Proposal for amendments to Draft new Regulation on uniform provisions concerning the approval of enhanced Child Restraint Systems used onboard of motor vehicles

Submitted by the expert from OICA and CLEPA

The text reproduced below was prepared by the expert from OICA and CLEPA. It is based on ECE/TRANS/WP.29/GRSP/2011/15. The modifications to the current text of the new ECE on Child Restraint Systems are marked in bold or strikethrough characters.

Figure 0(e)

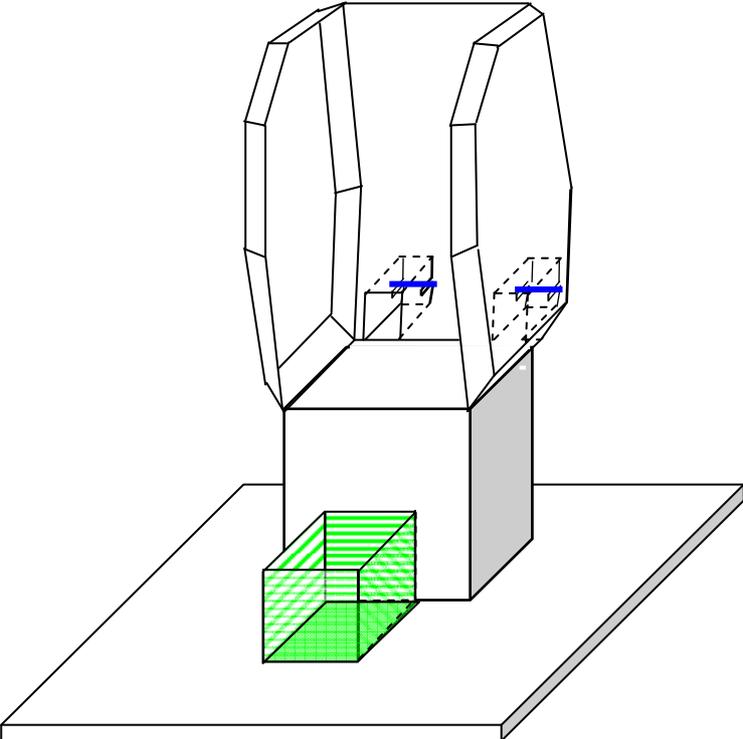
Figure 0(e) of paragraph 6.3.5.4. (former 6.3.5.2.) insert ISOFIX low anchorage bars (in blue) :

**ISOFIX axle
6 mm round**

A jig shall be used to check that the support-leg foot meets the requirements defined in paragraph 6.3.5.2~~4~~. (See figure 0(e)). As an alternative a computer simulation shall also be considered satisfactory.

The jig is defined as the ISOFIX CRF corresponding to the size class of the child restraint. The jig is expanded with two 6.0 mm diameter ISOFIX low anchorages. The striped box positioned in front of the jig is positioned and sized according paragraph 6.3.5.2~~4~~. The CRS shall have its attachments latched when conducting the assessment.

An **①**-Size Child Restraint System with a support-leg adjusted at any possible position, as checked by the jig, **shall must** meet the requirements of **paragraph §6.3.5.4. and its subparagraphs.**”

Figure 1: Side view of the support leg dimension assessment volume

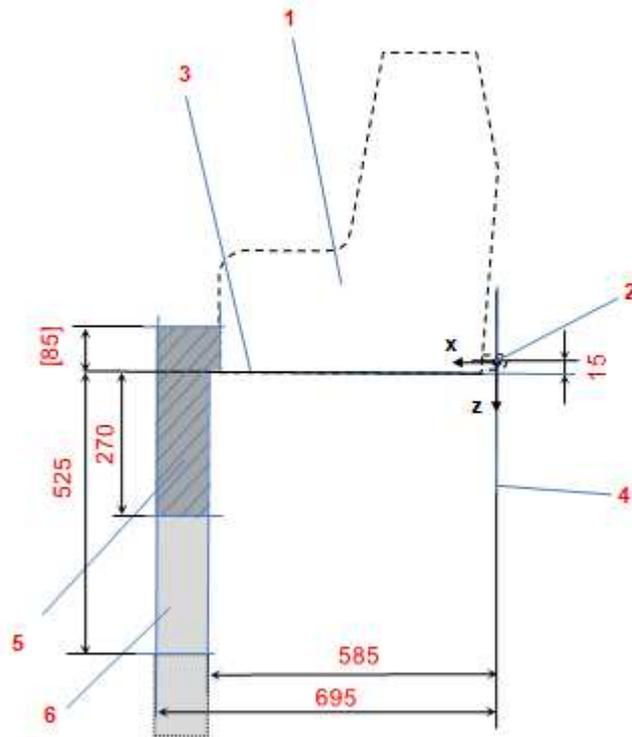
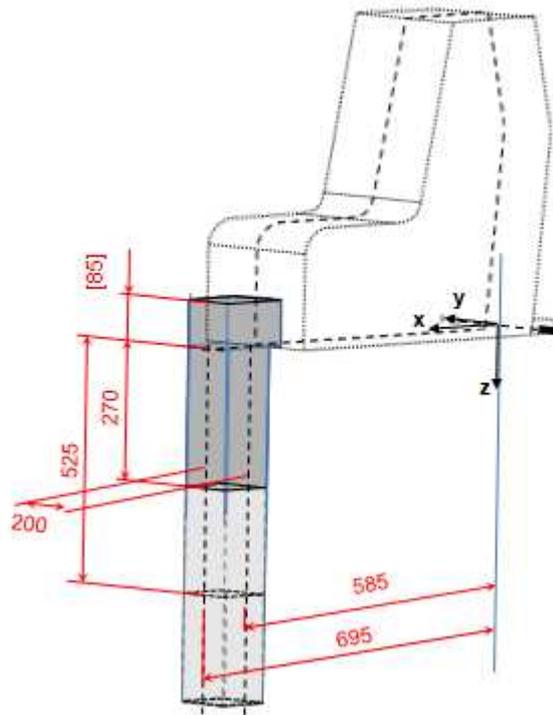
The support leg, incl. its attachment and support-leg foot has to completely lie within a support leg dimension assessment volume (see also figures 1 and 2 of annex 19 of this Regulation), which is defined as follows:

- In width by two planes parallel to and 100mm apart from the X-Z plane of the coordinate system defined in 6.3.5.; and

- In length by two planes perpendicular to the X-Y plane and X-Z plane [median longitudinal plane of the child restraint fixture] of the coordinate system defined above, 585mm and 695mm apart in X direction from the origin; and

- In height above the level of the CRF bottom surface by a plane parallel to and [85]mm above the CRF bottom surface. Below the level of the CRF bottom surface there shall be a limitation for rigid, non-adjustable parts in Z direction defined by a plane parallel to and 270mm below the CRF bottom surface, for parts adjustable in Z direction there shall be no limitation in height below the level of the CRF bottom surface.

Figure 3: Side view of the support leg foot assessment volume

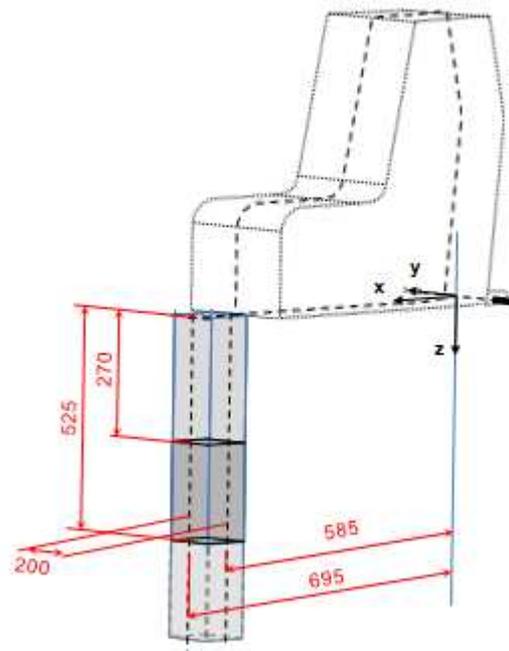
The support-leg shall be adjustable in order to ensure that the support-leg foot is able to reach at least any height between the upper and the lower height limit in z-direction of the support leg foot assessment volume as specified below (see also figure 3 and 4 of annex 19 of this Regulation). In case of incremental adjustment there shall be no step between two positions of more than 20mm.

The support leg foot assessment volume is defined:

- In width by two planes parallel to and 100mm apart from the X-Z plane of the coordinate system defined in 6.3.5.; and
- In length by two planes perpendicular to the x-y-plane and X-Y plane [median longitudinal plane of the child restraint fixture] of the coordinate system defined above, 585mm and 695mm apart in X direction from the origin; and
- In height by two planes parallel to the CRF bottom surface, one plane 270mm and a second plane 525mm below the CRF bottom surface.

It shall be permissible for the support-leg to be adjustable beyond the height limits in Z direction given below in order to reach additional positions above the upper and below the lower height limit in Z direction given by the support leg foot assessment volume, providing that no parts extend beyond the limiting planes in X and Y direction.”
